PD Modification Application: MM 24-0397

Development Services Department

1.0 APPLICATION SUMMARY

Case Reviewer: Chris Grandlienard, AICP

8.2.2 Proposed Site Plan (Full)

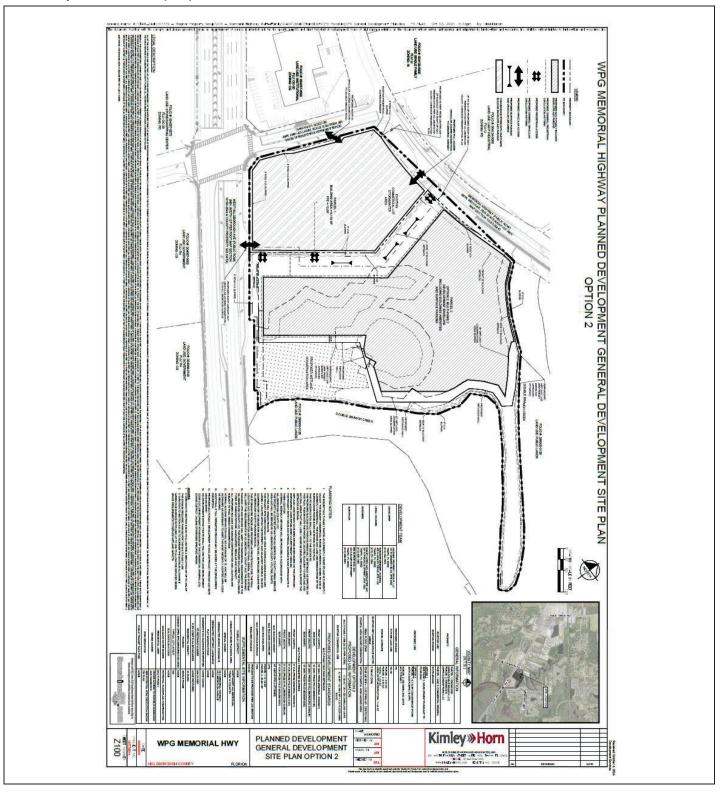
Prior to PD site plan certification, the developer shall revise the PD site plan to:

- 1. Remove all indication of the requested waivers from the site plan.
- 2. The max height will be revised from 60' ABOVE FFE to 68' ABOVE FFE for Multi-Family Max Building Height.

Proposed Modified TS-4 Roadway Section

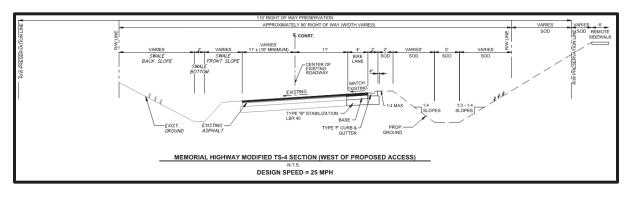
Considerations for the full implementation of the typical TS-4 section were made and our engineering opinion is that it is not practical as part of this project due to causing access slopes in excess of 10% for the existing commercial access driveway to the north and proposed pavement widening will directly conflict with the adjacent open swale drainage. Please refer to Exhibit D for the comparison of the existing access slope versus the TS-4 configuration that requires widening of the roadway to the north. Please note on Exhibit D Lane widths exceed the typical TS-4 11-feet wide at Memorial Highway station

206+37.11 and match existing conditions as they are shown transitioning to match the lane widths east of our project. Due to the excessive access slopes imposed on the north access driveway and the direct conflict with the existing functional open swale drainage system we are requesting that the scope of improvements north of the Memorial Highway centerline be limited to repaving and restriping the existing conditions.

The proposed modified roadway section for Double Branch Road, as described above, will enhance the traffic safety and operation of Double Branch Road between Hillsborough Avenue and Memorial Highway.

Proposed Modified TS-4 Roadway Section

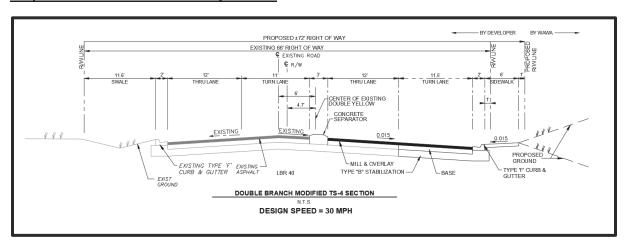
The applicant is seeking approval of a modified typical section detailed below for Double Branch Road. Improvements to Double Branch Road to the full TS-4 typical section are not feasible by this applicant due to geometric design constraints as depicted in exhibit B and limited available right-of-way.

It should be noted that apart from this request for a design exception an 11.5-feet right auxiliary lane into the site is required in accordance with the LDC access requirements and will necessitate ROW dedication totaling a ROW width of 91.5 feet under the full TS-4 typical section as modified above.

The proposed modified TS-4 section aims to improve the existing roadway infrastructure while considering several design considerations. Firstly, regarding the TS-4 typical section sidewalk improvements west of the existing southbound back of curb, it has been determined that this would be in direct conflict with existing drainage swales and stormwater conveyance infrastructure. Additionally, the presence of a mature 29" Oak located at the southwest corner of Double Branch Road and Memorial Highway means that the construction of the 5 feet sidewalk would impact the critical root zone. Therefore, the modified typical section requests the omission of sidewalk improvements west of the existing southbound back of curb.

Furthermore, the requested modified section includes the maintaining of existing 12 feet lane widths in accordance with pre-development meeting discussions with county staff and reasonable roadway use expectations. Additionally, the omission of the 7-feet buffered bike lanes is requested to mitigate unsafe intersection lane shift as detailed in exhibit B.

Lastly, due to the limited 66 feet of available right-of-way, we request a 6-feet sidewalk adjacent to the back of curb on the eastern side of the ROW which shall limit the dedication area required. This will provide sufficient existing ROW width to fit the proposed modified TS-4 section except where the 11.5 feet auxiliary right turn lane is required. To which right-of-way dedication is proposed accordingly.

The proposed modified roadway section for Double Branch Road, as described above, will enhance the traffic safety and operation of Double Branch Road between Hillsborough Avenue and Memorial Highway.
